STAFF REPORT: OCTOBER 14, 2020 MEETING

APPLICATION NUMBER: 20-6863

ADDRESS: 7949 EAST LAFAYETTE

SCOPE OF WORK: REPLACE WINDOWS, REHAB EXTERIOR, REMOVE EXTERIOR BASEMENT ENTRANCE ENCLOSURES

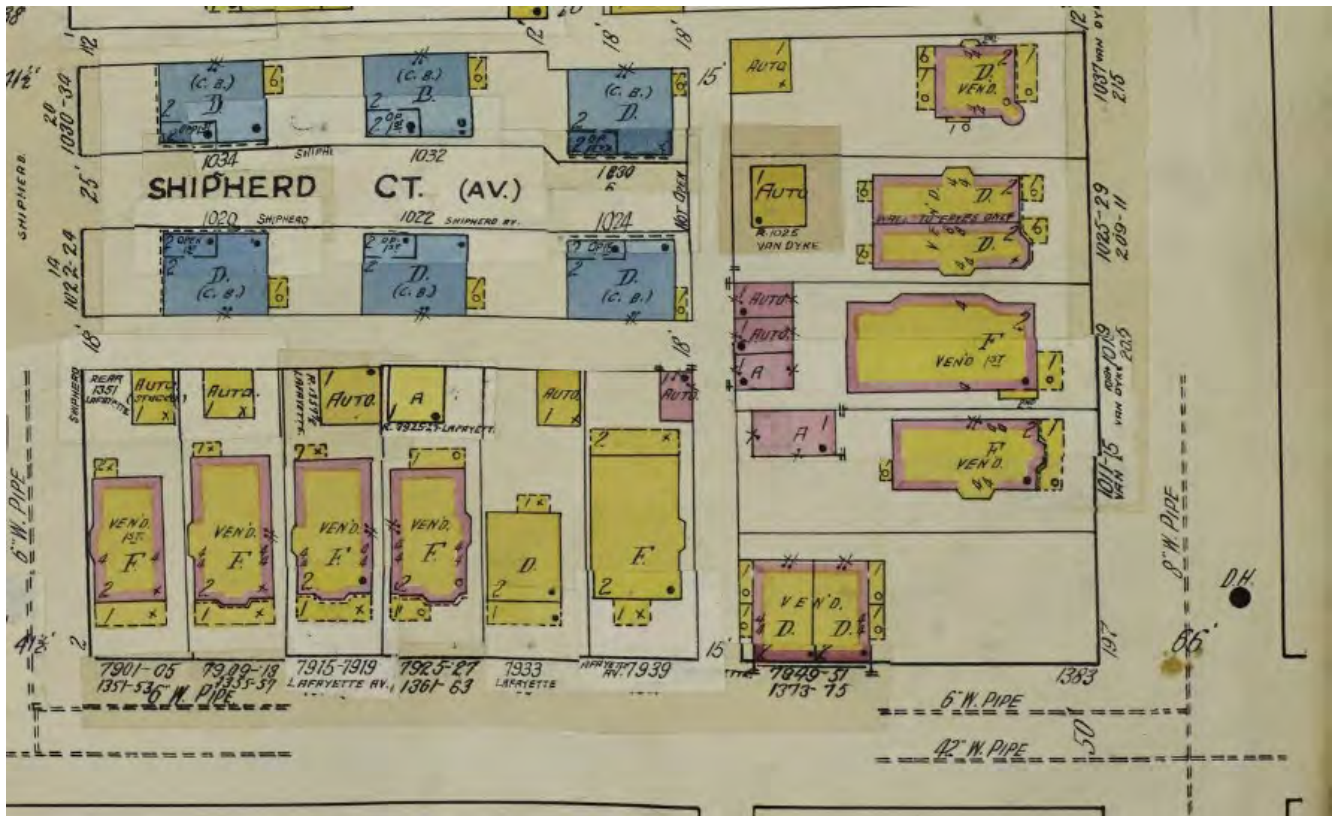
Staff also has concerns about the removal of the basement enclosures at rear portion of the porches by blocking access with a concrete cap. The applicant contends that "based on observations of modern framing members within the basement stair enclosures, we believe these

were added after the completion of the building.” However Sanborn maps indicate that the entire wooden porch structures are present at the time of early 20th century Sanborn map and that they are likely original construction. If they are not original, they are of historic age and contribute to the overall character of the property. Staff would support the rehabilitation of these entrances along with additional measures taken to secure the entrances if that is a concern driving their removal, but ultimately it is staff’s opinion that these features should be retained.

- **Overall Exterior Rehabilitation:** Staff recommends that the Commission issue a Certificate of Appropriateness for the current application to rehab 7949 Lafayette based on the Secretary of the Interiors Standards for Rehabilitation with the following conditions:
 - All existing windows with both sashes intact are retained and repaired.
 - Applicant retains, restores and secures existing porch enclosure leading to basement.
 - Glass block windows adhere to HDC standards for installation.
 - Applicant submits full details of painting proposal to conform to Color Chart C.
 - Staff to review revised proposal prior to issuance of COA.

Sheet No. :
A3.1

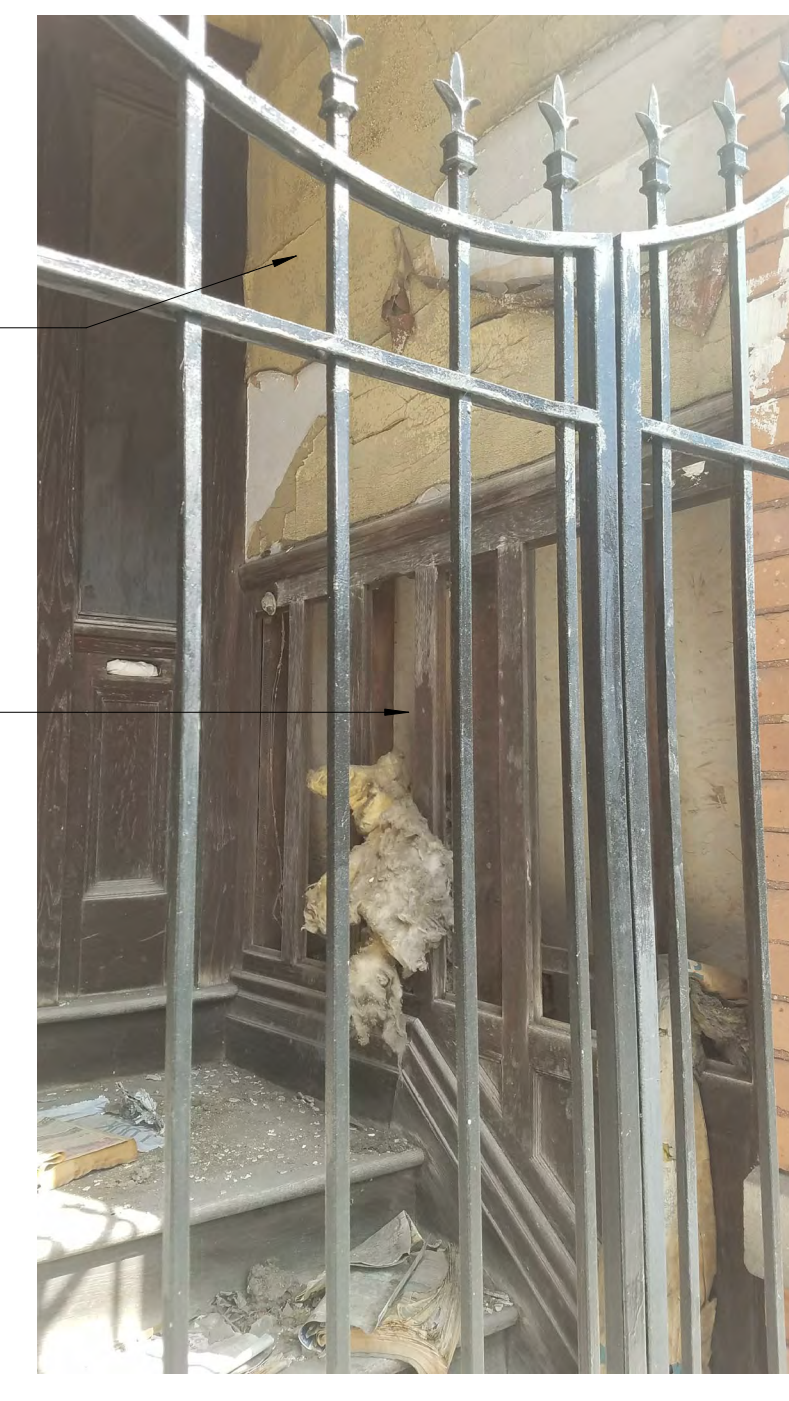
3. PARTIALLY INFILL EXISTING WINDOW OPENING WITH BRICK TO MATCH EXISTING. NEW SILL HEIGHT TO MATCH ADJACENT SILL HEIGHT. SALVAGE EXISTING STONE SILL AND REINSTALL AT NEW HEIGHT.

NEW SILL HEIGHT TO MATCH ADJACENT WINDOWS. SALVAGE EXISTING STONE SILL AND REINSTALL AT NEW HEIGHT.

1 PORCH DETAIL
 SCALE: 1/2" = 1'-0"

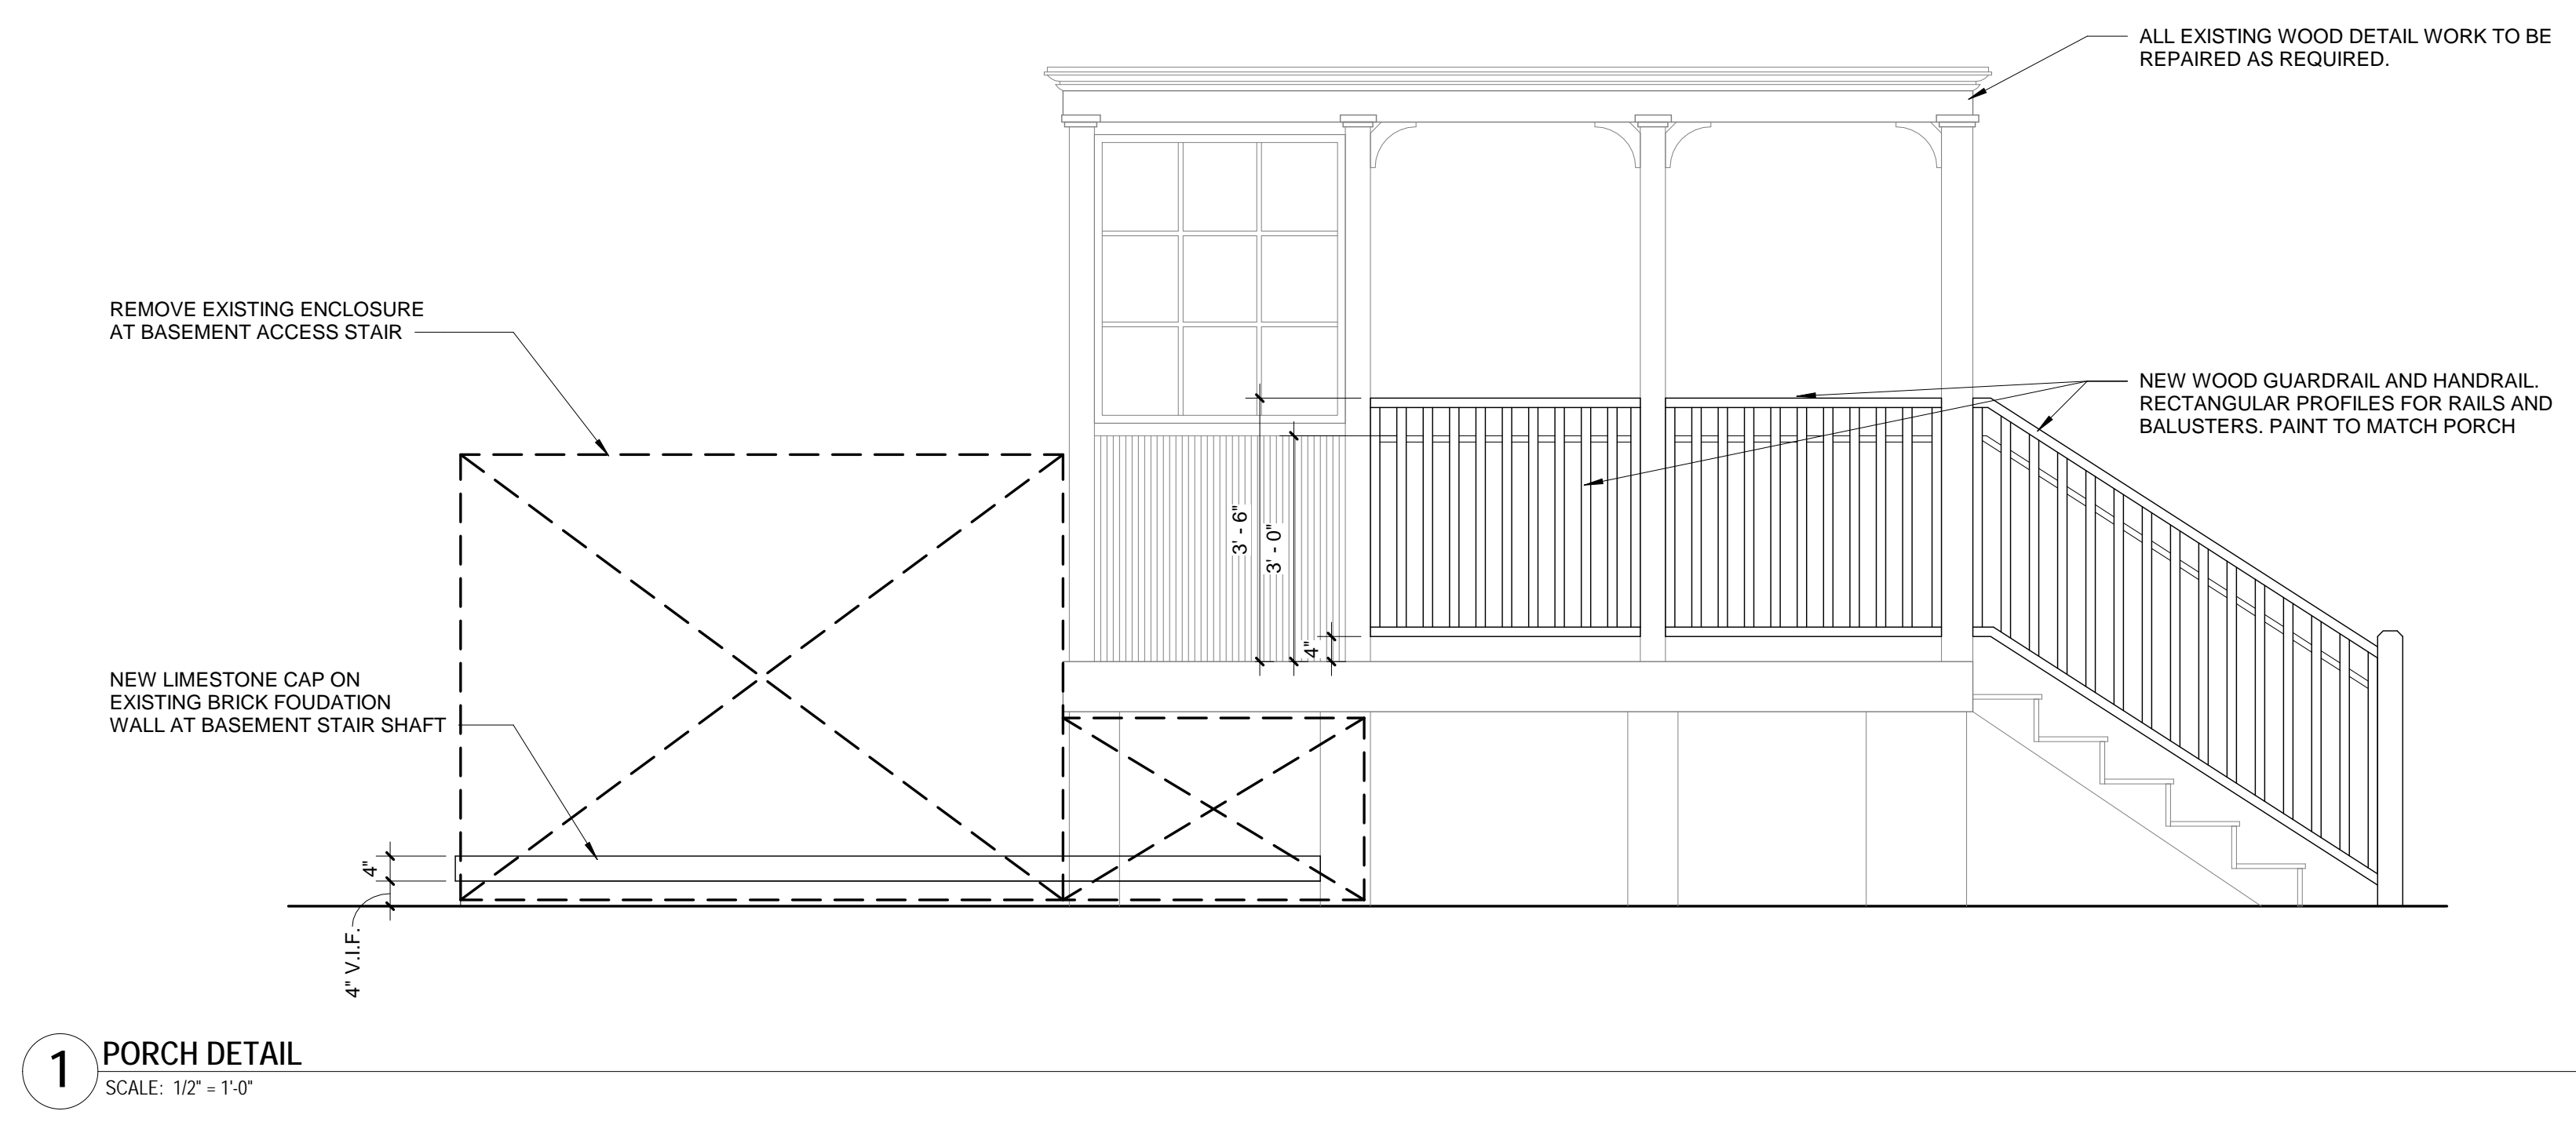
BASED ON OBSERVATIONS OF MORE MODERN FRAMING MEMBERS WITHIN THE BASEMENT STAIR ENCLOSURES, WE BELIEVE THESE WERE ADDED AFTER THE COMPLETION OF THE BUILDING.

THE PROPOSAL IS TO REMOVE THE REAR ENCLOSURES OF THE BASEMENT STAIRS AND INSTALL A LIMESTONE CAP ON TOP OF THE BRICK STAIR ENCLOSURE FOUNDATION.

Proposed Window dimensional Comparison - Double Hung Windows

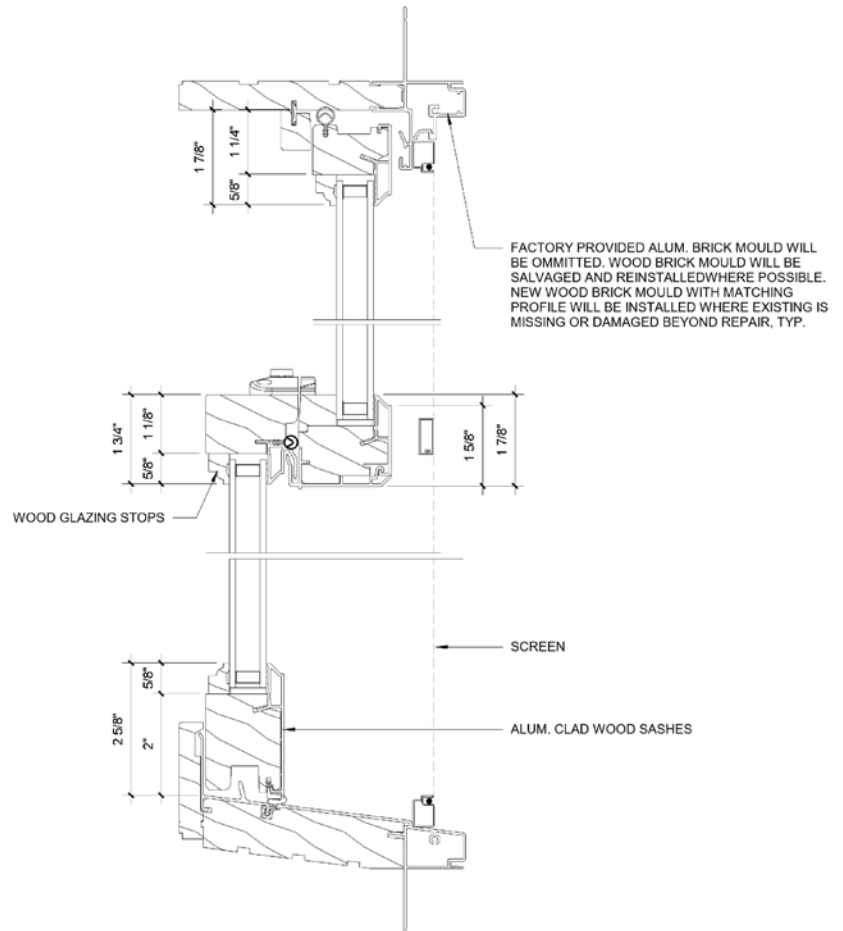
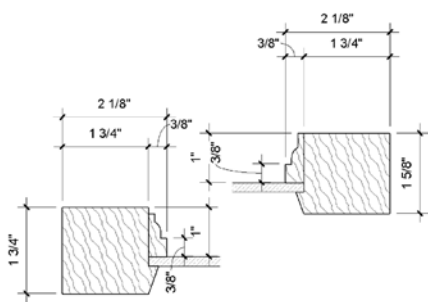
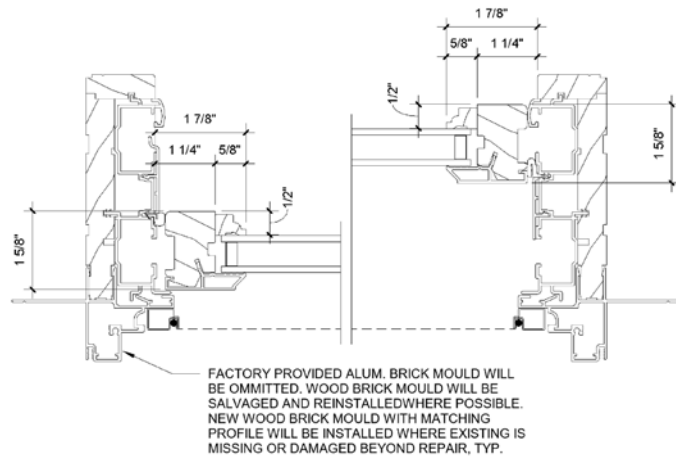
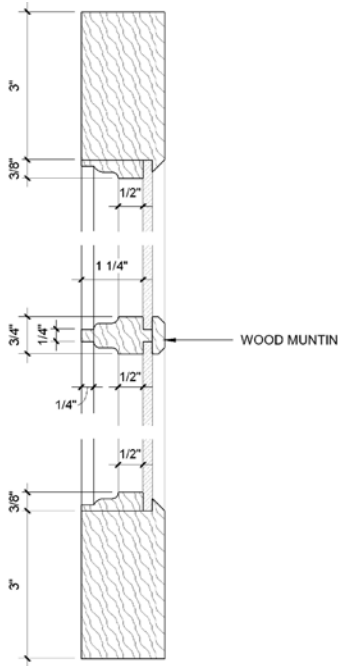
- The existing wood double hung windows feature a 3-3/8" lower sash and a 2-3/8" upper sash.
 - The proposed wood double hung windows feature a 2-5/8" aluminum clad wood lower sash (approx. 3/4" smaller) and a 1-7/8" upper sash (approx. 1/2" smaller).

- **Window Replacement:** Based on the window assessment provided, there is not enough documentation for staff to recommend full replacement of the double hung windows, based on The Secretary of the Interior’s Standards for Rehabilitation 6, as mentioned above. It is staff’s opinion that the majority of remaining windows can be retained and repaired. In the case of window replacement where no sash currently exists, it is staff’s opinion the proposed aluminum clad wood windows would suffice to replace the existing 1/1 double hung windows if the existing brick mold can be retained. However, it should be further noted that if the applicant seeks to have a uniform look across all windows, then this could be achieved by repairing the existing windows and installing wood windows with even closer dimensions to the original wood windows.
